Agenda
Lane Cove Local Planning Panel Meeting
2 June 2026

Lane Cove Local Planning Panel Meeting 02 June 2026
21 - 25 AUSTIN STREET, LANE COVE

Item No: LPP9/26
Subject: 21 - 25 Austin Street, Lane Cove
Record No: DA25/153-01 - 36293/26
Division: Planning and Sustainability Division
Author(s): Andrew Bland

Figure 29: Building A - Northern Setback - multiple walls 4.9m excavation - no +3m min width (Source: Council's Landscape Officer)

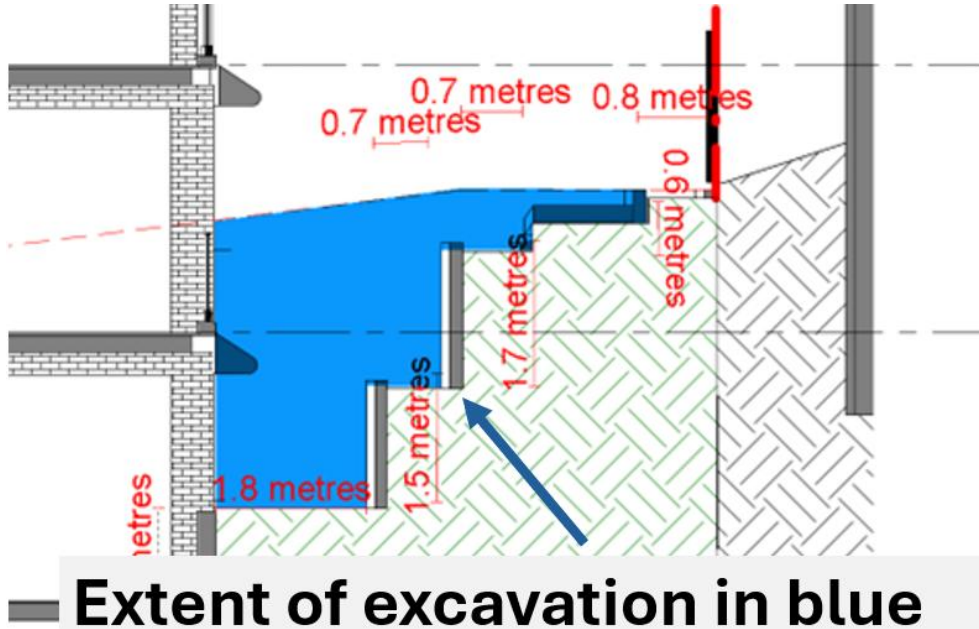
Detail sections of the proposal have been marked up showing the extent of excavation and retaining walls below:

Figure 31: Austin Street Setback - + 3.5m excavation - additional wall required to resolve level change at lot boundary Plan shows only one small area of planting which is 3m W - otherwise widths are less than 2.2m (Source: Council's Landscape Officer)

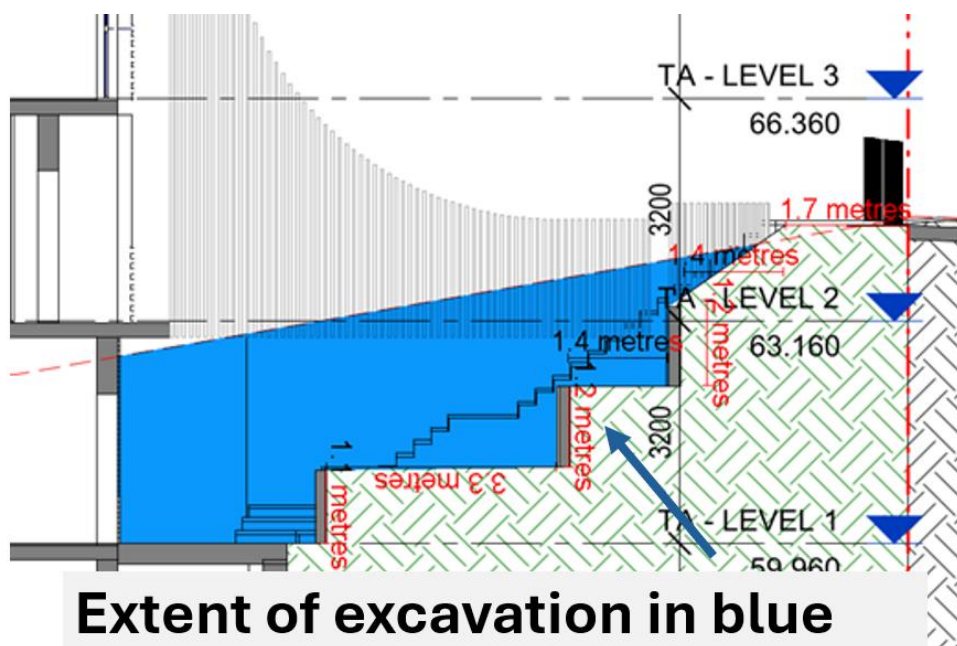
Council also notes that all retaining walls are currently very thin walls with no footings, these are likely to widen during design development. Council requested additional information regarding proposed material, thickness and footing size of proposed retaining walls to properly assess the impacts to landscaping and deep soil, this was not provided.

Figure 33: Tree encroachment plan (Source: Council's Landscape Officer)

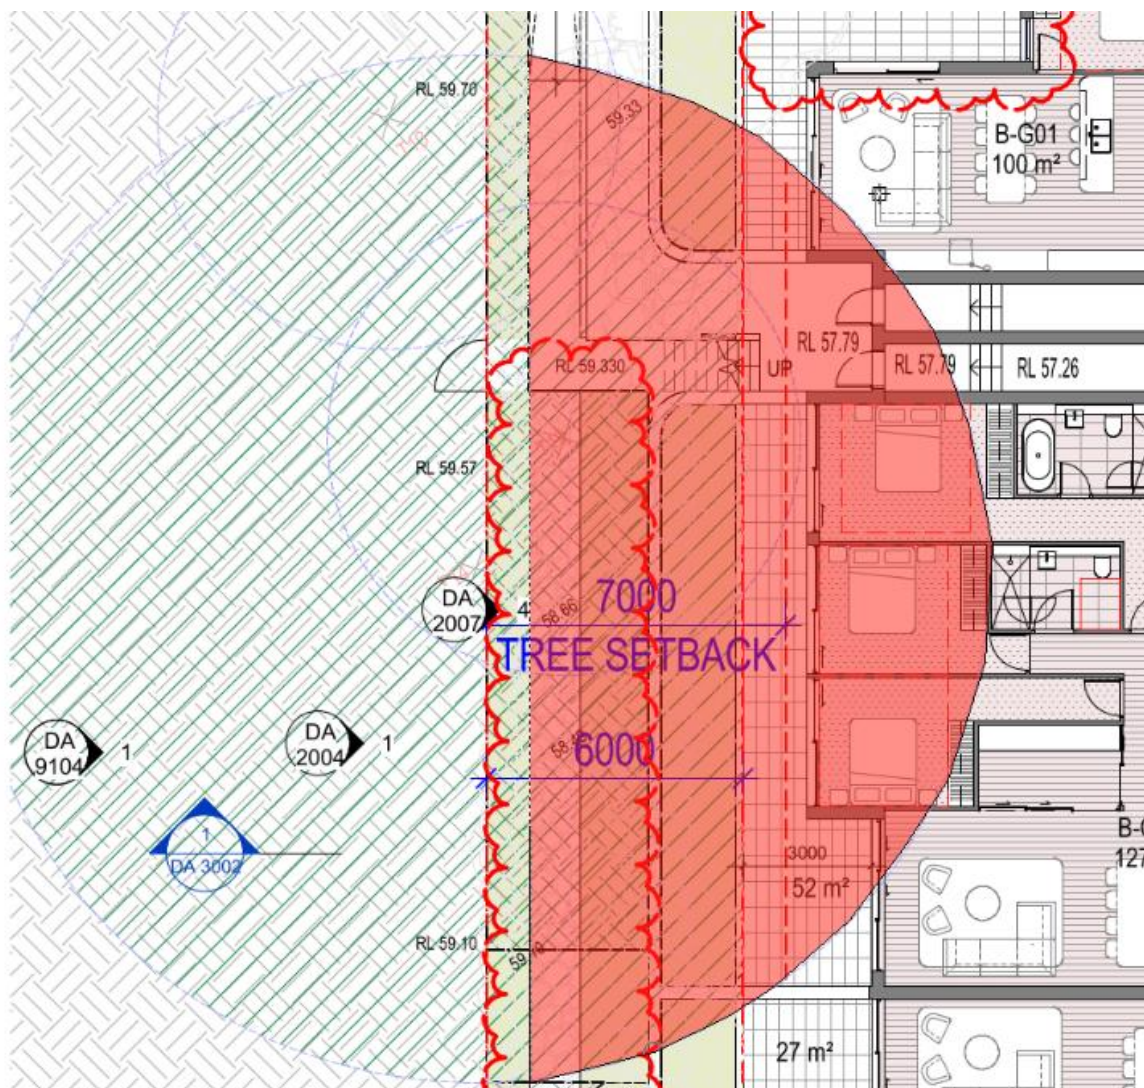
Refer to Council's Arborist comments on the potential impacts to existing trees marked for retention on Council property along the rear of the site. The consultant Arborist conducted root mapping for this tree @7m; however, the proposal shows a +1m retaining wall crossing the SRZ @4m. Additionally, a new path has been proposed in the current architectural package that shows a path proposed directly through the trunk of Tree 12 (scheduled for retention) and within 2m of Tree 14.

Council calculates that the TPZ encroachment of Tree 14 is nominally **195m² / 43%**, as per **Figure 33** below. This is contrary to the Arborist assessment of 11.5%.
